3.5 Missile Protection

The information in this section of the reference ABWR DCD, including all subsections, tables, and figures, is incorporated by reference with following departure and supplements.

STP DEP 3.5-1 (Table 3.5-1 and Figure 3.5-2)

Figure 3.5-2 Low-Trajectory Turbine Missile Ejection Zone

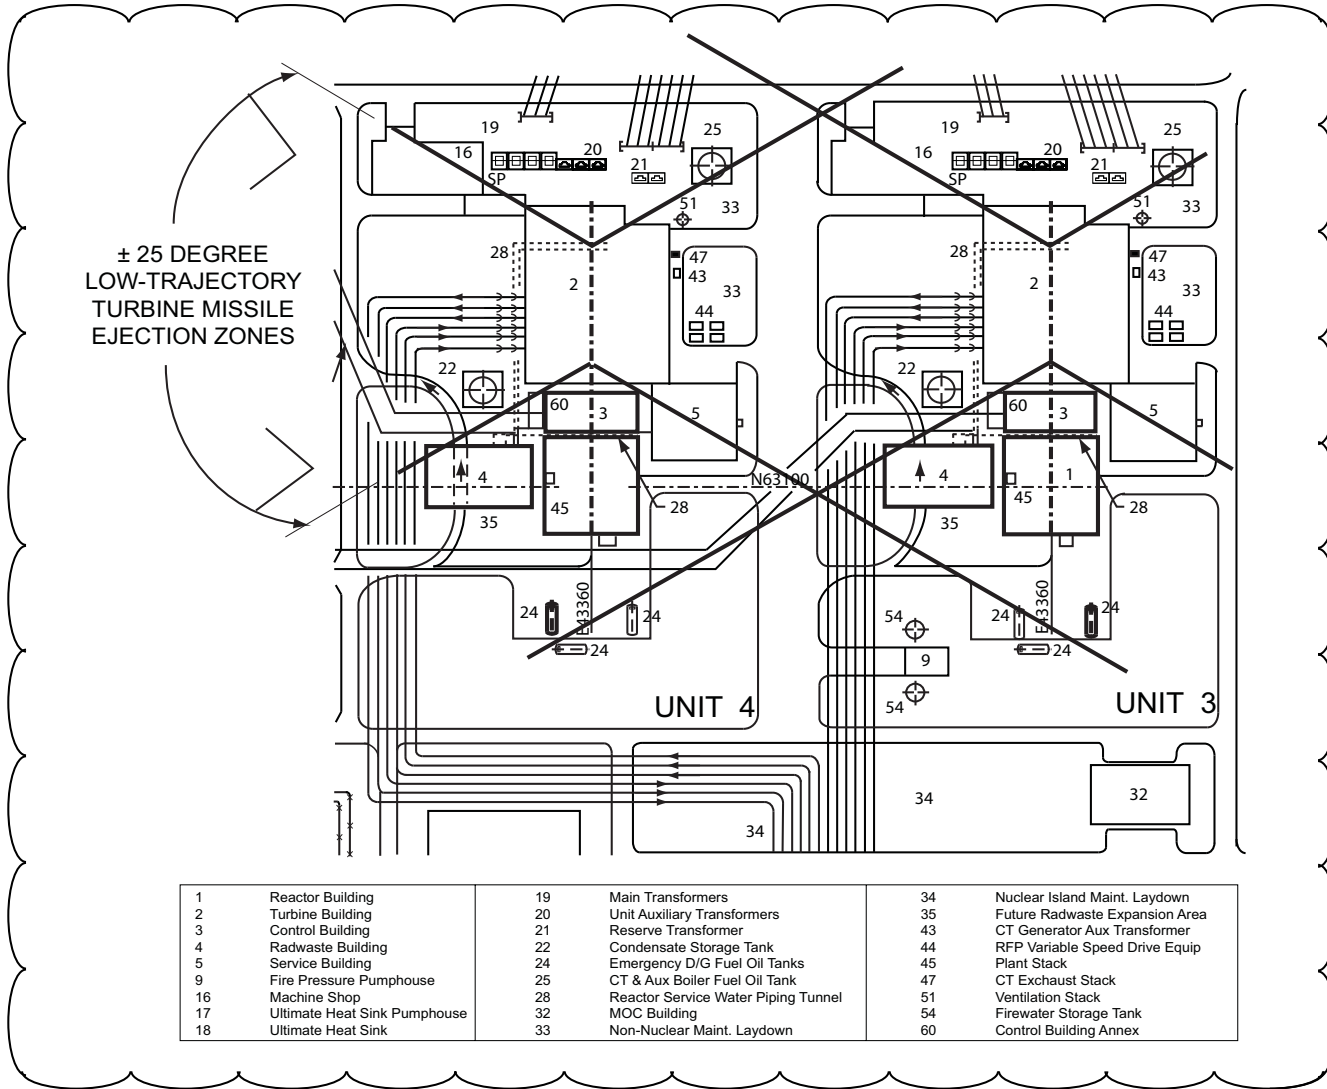
STP DEP 3.5-1

~~Acceptance Criteria 1 of SRP Section 3.5.1.3 considers a plant with a favorable turbine generator placement and orientation and adhering to the guidelines of Regulatory Guide 1.115 adequately protected against turbine missile hazards. Further, this criterion specifies that exclusions of safety related structures, systems or components from low trajectory turbine missile strike zones constitutes adequate protection against low trajectory turbine missiles. The turbine generator placement and orientation of the ABWR Standard Plant meets the guidelines of Regulatory Guide 1.115 as illustrated in Figure 3.5-2.~~

The STP 3 & 4 turbine generator placement and orientation in relation to essential systems of the adjoining unit are illustrated on Figure 3.5-2. Per Regulatory Guide 1.115, the STP 3 & 4 turbine generator placement and orientation is considered unfavorable. Per Acceptance Criteria 1 of Standard Review Plan Section 3.5.1.3 for unfavorable turbine generators, a value of 10^{-2} per year per plant was chosen as a conservative value for the product of strike probability (P_2) and damage probability (P_3). The criteria for unfavorable turbine generator orientation given in Standard Review Plan Table 3.5.1.3-1 and provided in Table 3.5-1 was assumed for the missile generation probability (P_1). The resulting probability of unacceptable damage from a main steam turbine missile (P_4), which is $P_1 \times P_2 \times P_3$, is less than 10^{-7} per year per plant.

Therefore STP 3 & 4 main steam turbine generator placement and orientation meets the acceptance criteria of Standard Review Plan 3.5.1.3 and the guidelines of Regulatory Guide 1.115.
